**Bulletin**

MODEL: BENTLEY MARK VI

FOR INFORMATION:FRONT SHOCK DAMPER SETTINGS.Increased Bump Load.

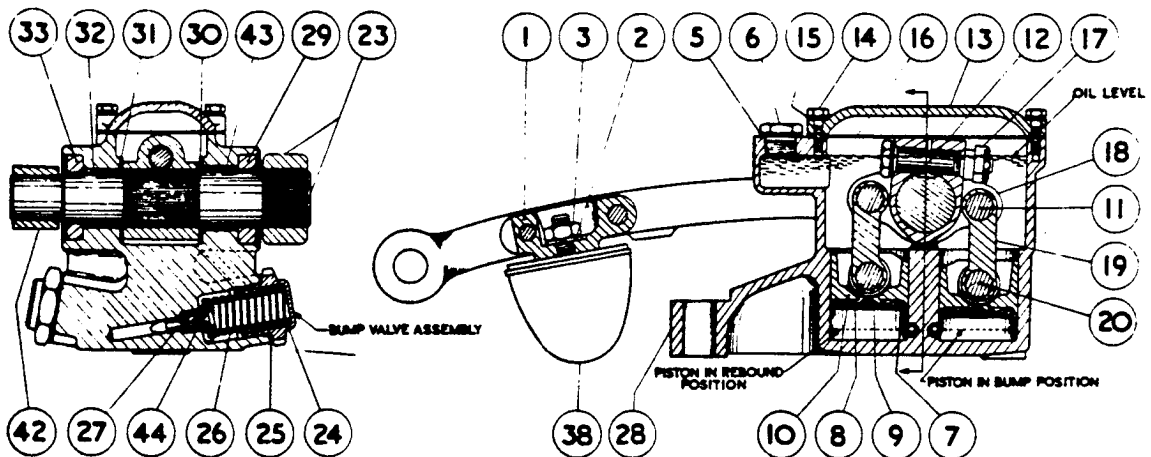
This Bulletin describes the procedure for raising the loading of the bump valve by replacing the existing bump valve spring with a new spring of increased strength, raising the bump loadings to 95-105 lbs., the rebound loading remaining unaffected. The part number of the spring giving the 95-105 lbs. bump loading is RF.5022, these are obtainable from Hythe Road Service Depot.

It is important to note that the bump valve cap of the L.H. damper is at the FRONT of the damper casing, whereas on the R.H. damper, the bump valve cap is at the REAR. In each case, the rebound valve cap is on the opposite side of the casing.

4. Remove the bump valve cap (24), aluminium washer (25) bump valve spring (26), bump valve (27), also any packing washers which may be fitted between the spring and the cap.

Clean the parts and replace in the damper using a new bump valve spring in place of the old one which was removed, also remove any packing washers, but do not tighten the valve cap.

FIG. 5. MODIFICATION TO SPRING COMPRESSING TOOL.

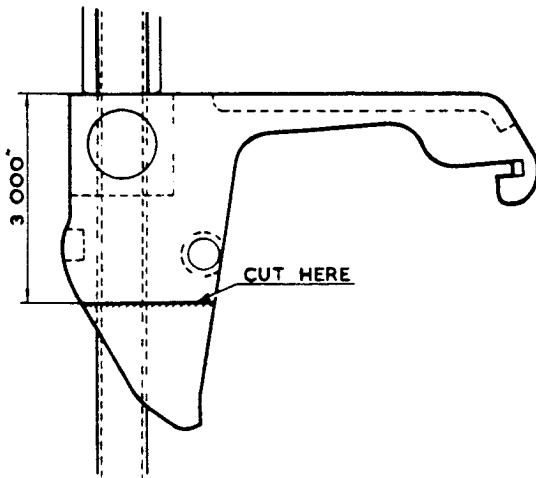
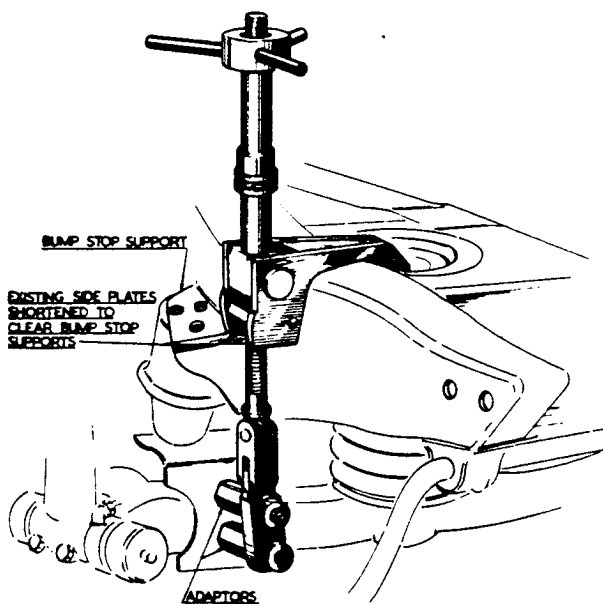
In order to make the early type front spring compressing tool suitable for all types of chassis, the side plates of the clamp should be shortened to the dimension shown in Fig.5. A modified tool in this respect is shown in position in Fig.6. The later type production of this tool has shortened side plates.

FIG. 7. ADAPTORS - STUDS - TORQUE ARM.

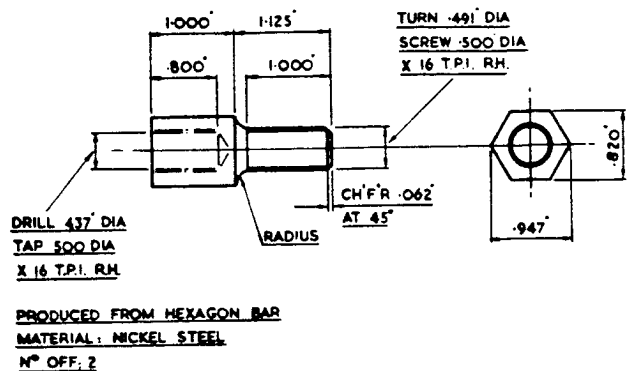
On certain chassis it may be necessary to screw two adaptors (extension pieces) on to the two 1/2" (B.S.F.) studs at the front of the torque arm in order that a straight pull can be obtained with the tool when compressing a spring. These adaptors are shown in position in Fig.6. They are not supplied but can be made in accordance with details given in Fig.7.

FIG. 3.

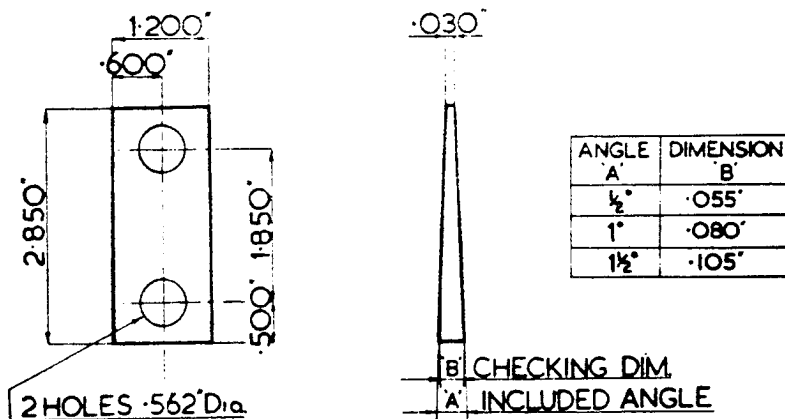
where castor angle is changed in a positive direction, it is possible that longer studs KB.963/Z-Torque arm will be required. A drawing of the taper packings required is given herewith (Fig.3) in order that they may be made up as required. The maximum change recommended is 1 1/2°.

MATL: LOW CARBON STEEL

FIG. 1.

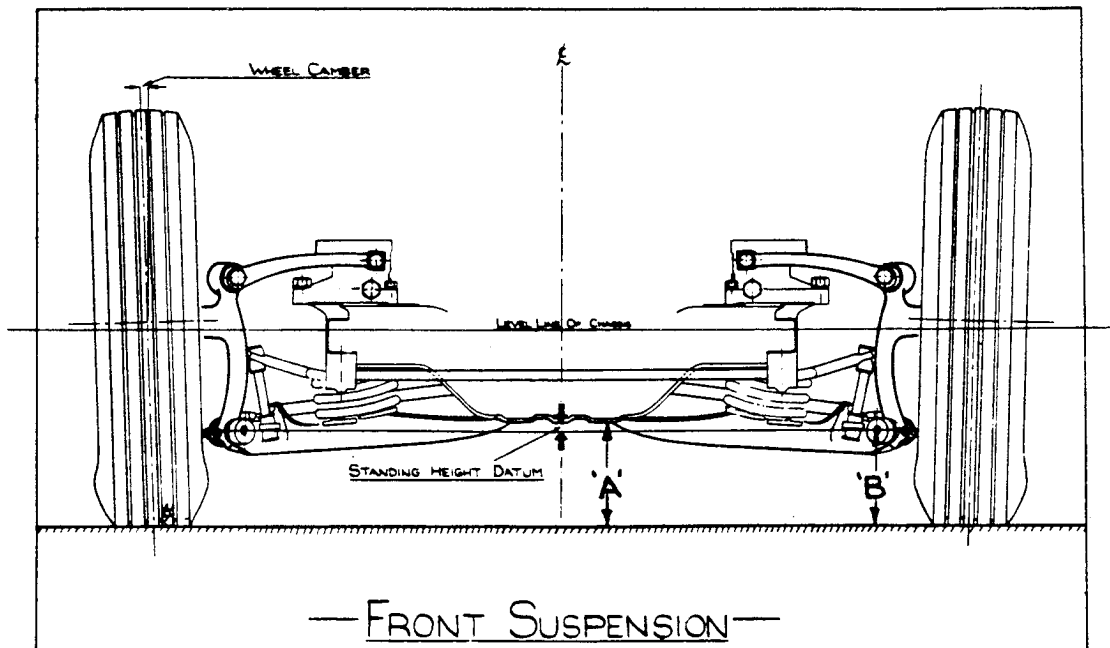
In consequence of the changes in the geometry of the radius arms mentioned above, the datum for measuring the standing height has been shifted relative to the ground as compared with the original design, and although the frame is .400" (10 m/m) higher than formerly, the reduced angularity of the lower radius arms means that the measurement of standing height can now become a negative figure.

.400" (10 m/m) negative  
to  
.200" (5m/m) positive

.600" (15 m/m) positive  
to  
1.200" (30 m/m) positive

A negative reading is when dimension 'B' Fig.1 is greater than dimension 'A'  
A positive reading is when dimension 'A' is greater than dimension 'B'.

FIG. 2.

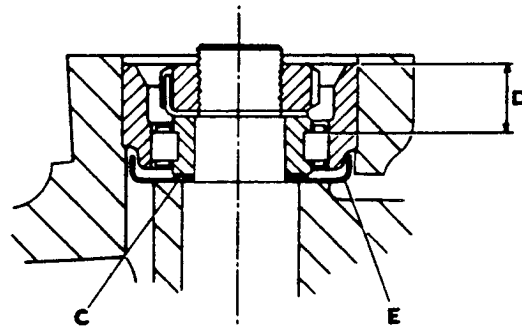
- (iii) Place a small straight-edge across the top face of the outer race of the upper roller bearing assembly of the pivot pin (not across the top face of the stub axle). With the rule of a small depth gauge, measure the distance downwards from the top face of the outer race to the top face of one of the rollers (not the brass roller cage), i.e. dimension 'D' Fig. 2 and note.

- a) If dimension 'D' is within the limits of .430" - .480" (10.9 - 12.2 m/m), this is correct.
  - b) If dimension 'D' is between the limits of .480" - .515" (12.2-13 m/m), then it will be necessary to remove the pivot pin and fit a .040" (1 m/m) thick packing washer ('C' Fig.2), Part No.R-4468, between the oil trough ('E') and the inner roller race.

- c) If dimension 'D' is over .515" (13 m/m), fit two packing washers.
- (iv) Having refitted the pivot pin and fully tightened the nut, check that the stub axle can be moved freely from one full lock to another, apart from the normal drag caused by the felt washer at the lower end of the yoke.

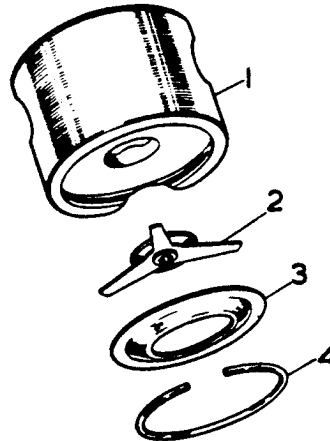
With the introduction of the revised steering geometry from chassis number B.1.GT onwards, a packing piece was fitted between the cross steering lever and the flange on the stub axle assembly to which the cross steering lever is bolted. It has been found that this packing piece is not essential and it has been deleted on production from chassis number B.89.PU onwards. In consequence shorter bolts, part number FB.4991, are fitted in place of the bolts RF.8198, and are the only bolts now available as replacements.

Should it at any time be necessary to replace the cross steering lever bolts, the shorter bolts, FB.4991, should be fitted and the packing piece discarded.
